T.S.S. 'AVALONA STAR' OIL FUEL BUNKERS.

APPROVED BY
LLOYD'S REGISTER OF SHIPPING
Hickson
DATE 2.12.31

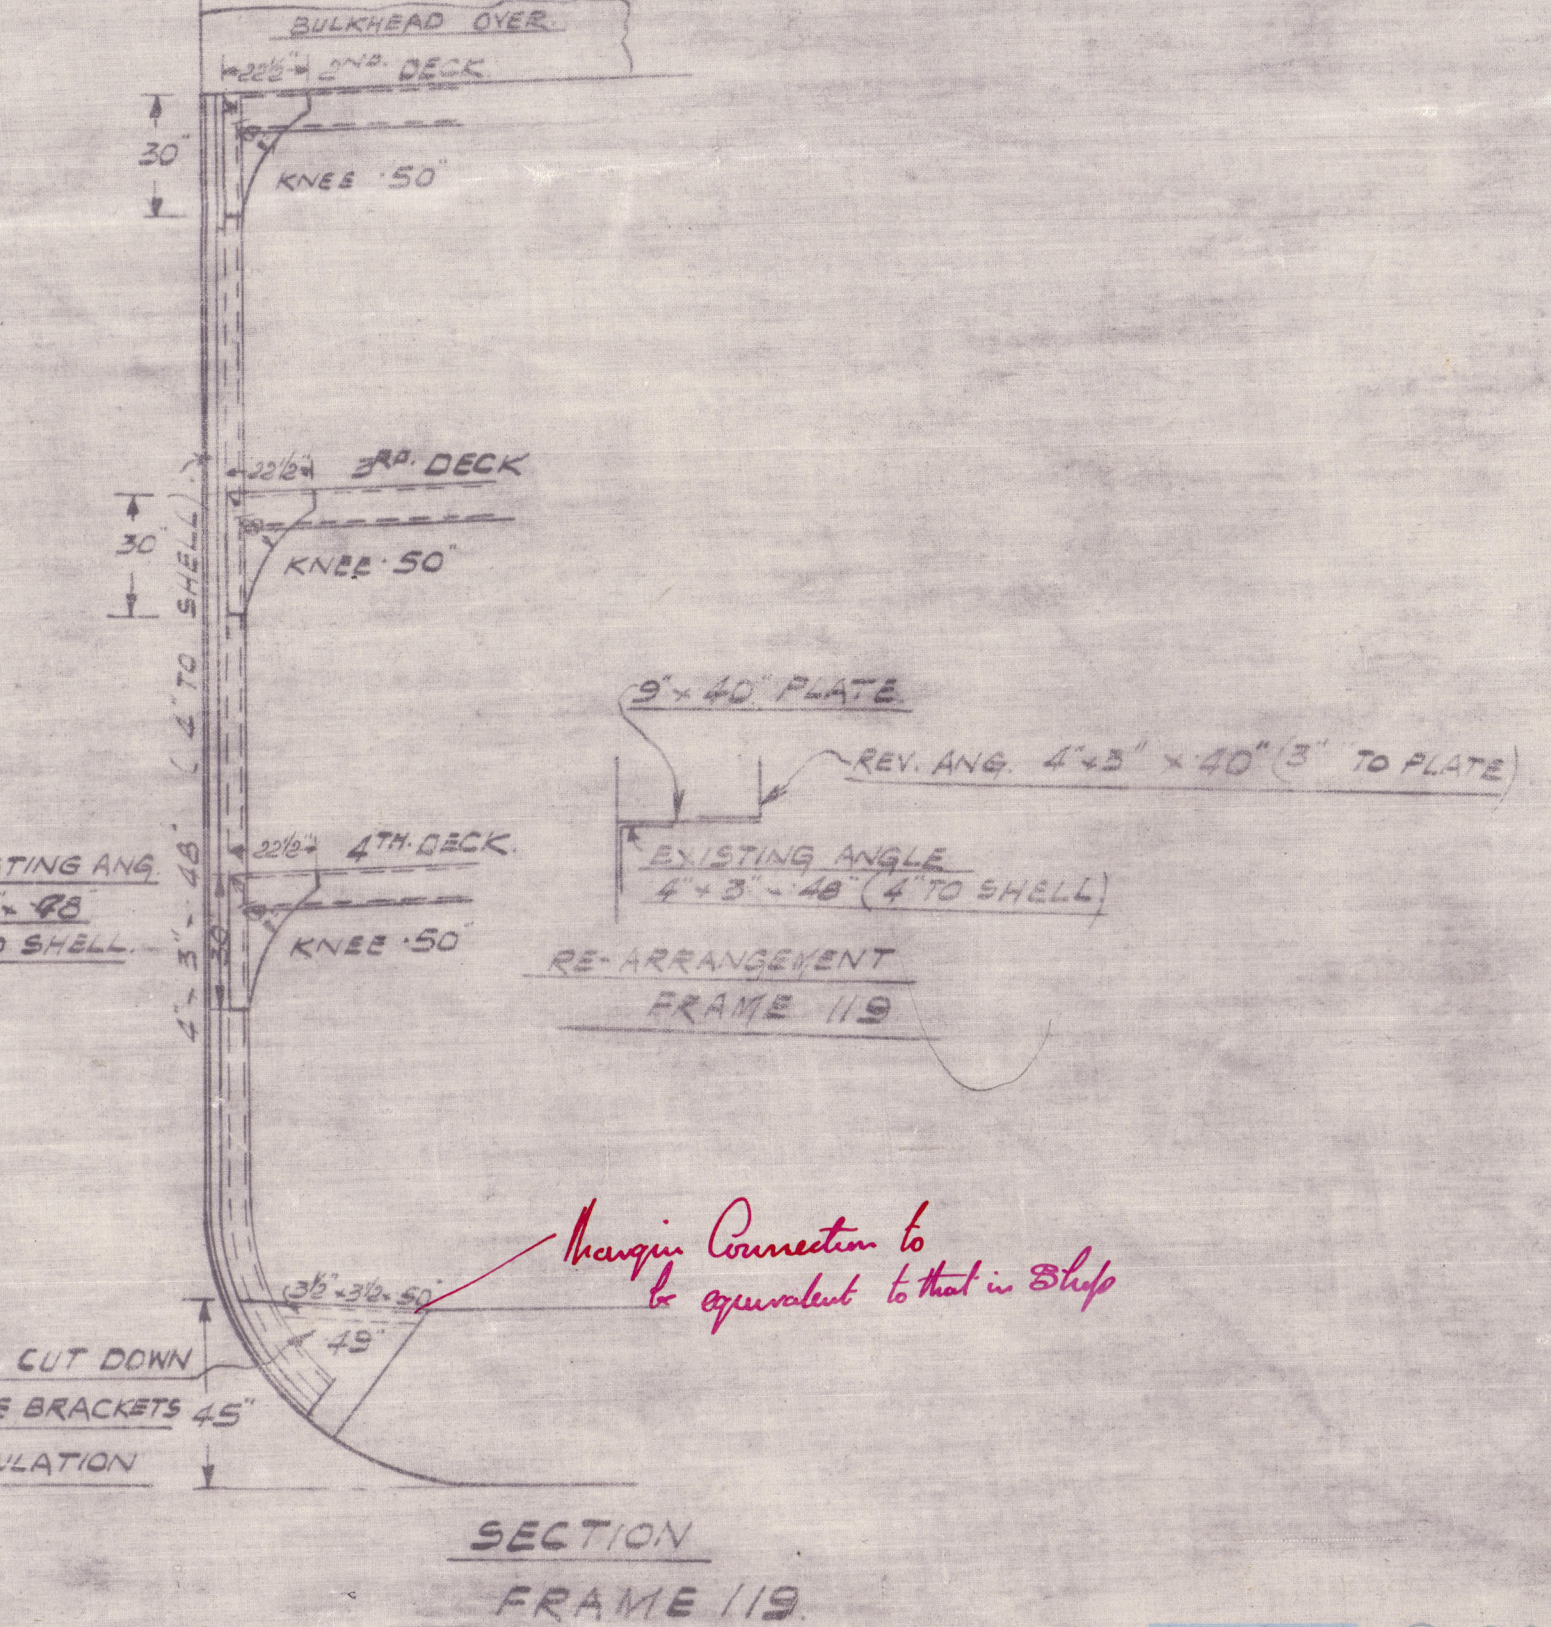
Notes: If these bulkheads are not light to 5' 6" high, they must be reinforced to 10' 6" high. If these bulkheads are not light to 5' 6" high, they must be reinforced to 10' 6" high. If these bulkheads are not light to 5' 6" high, they must be reinforced to 10' 6" high.
